**DEVELOPMENT CONCEPT PLAN  
AND  
ENVIRONMENTAL ASSESSMENT**

**WEST DISTRICT  
PINNACLES NATIONAL MONUMENT**

National Park Service  
Western Regional Office  
January, 1991

### **PUBLIC COMMENTS ON THE DRAFT PLAN AND ENVIRONMENTAL ASSESSMENT**

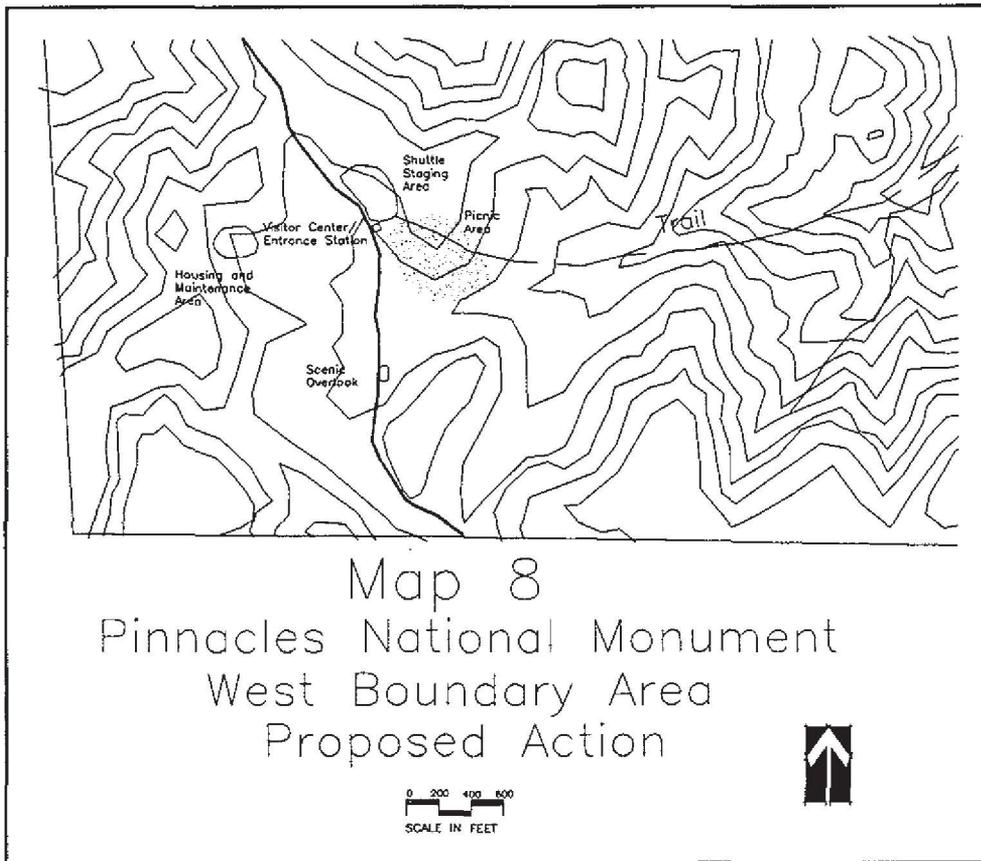
The shuttle from the West Boundary area is an excellent proposal for reducing congestion at peak periods; therefore, we are puzzled that the plan appears to call for *increased* parking in the Chaparral area by expanding into the disturbed area now occupied by structures that are to be removed. We would urge that the total parking spaces *not* be increased, but that the parking area should be shifted to the south so that the northern portion of the existing area can be restored to native riparian vegetation. In addition, the existing restroom should be moved out of the riparian corridor to a less intrusive location as soon as possible, rather than waiting until the "end of its useful life." We have long deplored the impacts of these facilities on the streamside vegetation and their high visibility from the High Peaks Trail, and we would therefore urge that their relocation should be a high priority.

More should be done to eliminate adverse visual factors. Map 7 Pinnacles National Monument Chaparral Area Proposed Action shows that the present Chalona parking lot would be continued. While the plan does make passing reference to the long term goal of

Under the Proposed Action the existing parking area at the Chaparral area is to be retained for the present time. I recommend that you close and restore the existing parking area as one of the first steps of implementing the final plan. This could be done by enlarging the new parking area on a temporary basis to accommodate about the same number of vehicles as the existing lot. Then when visitor use

1. The draft plan provided ultimately for elimination of the existing parking lot once west side use justified a year-around shuttle operation. The plan has been revised to provide for elimination of the main parking lot and restoration of the area to natural vegetation once the housing and maintenance facilities have been relocated from Chaparral, and a smaller parking lot has been developed south of the creek crossing. Hence there will be no interim increase in parking at the Chaparral area.

3. The plan provides for elimination of the large parking lot at Chaparral and development of a smaller lot in the area now occupied by the housing and maintenance complex.

1. The proposed parking lot will be topographically screened from most points on the high peaks trails and from all major vistas.
2. The plan has been revised to make the new parking lot the terminus in the Chaparral area. Parking will be located as close as practicable to the south to ensure good screening from the high peaks trails.

3. The plan provides for early elimination and restoration of the existing parking lot, and the implementation of a shuttle program as needed.
4. The Balconies Trail is currently wheelchair accessible for approximately half a mile, providing good opportunities to experience the phenomena of the Pinnacles. Possibilities for further enhancing the accessibility of this trail will be considered in the context of restoration of the main parking lot and redesign of the trail system in the Chaparral area.
